Staff Report PC21-016-PP

Jackson Run South Condos and Waivers

Docket PC21-016-PP – Primary Plat and Waiver – Jackson Run South Condos and Waivers

JACKSON RUN SOUTH PRIMARY PLAT WHITESTOWN, INDIANA

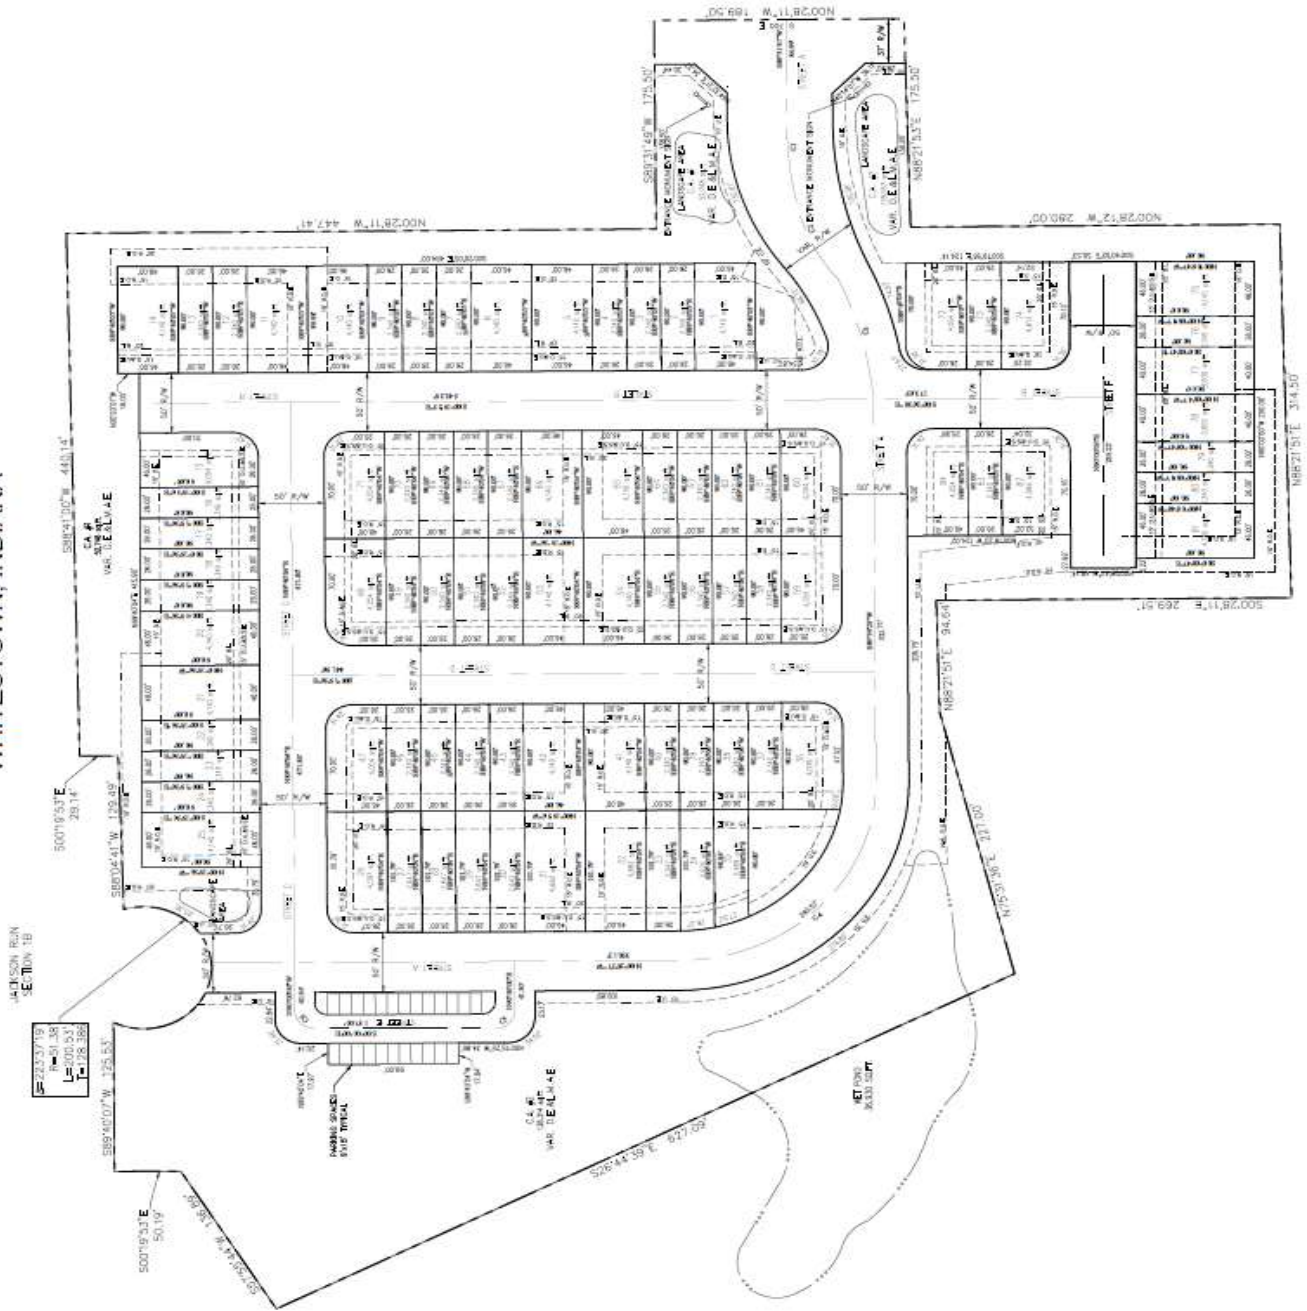
If the Whitestown Plan Commission approves the proposed Primary Plat, a condition/commitment should be placed that the Common Area will be split into two lots, the north part being dedicated to the Town as Block A and the second to remain Common Area under the proposed development.
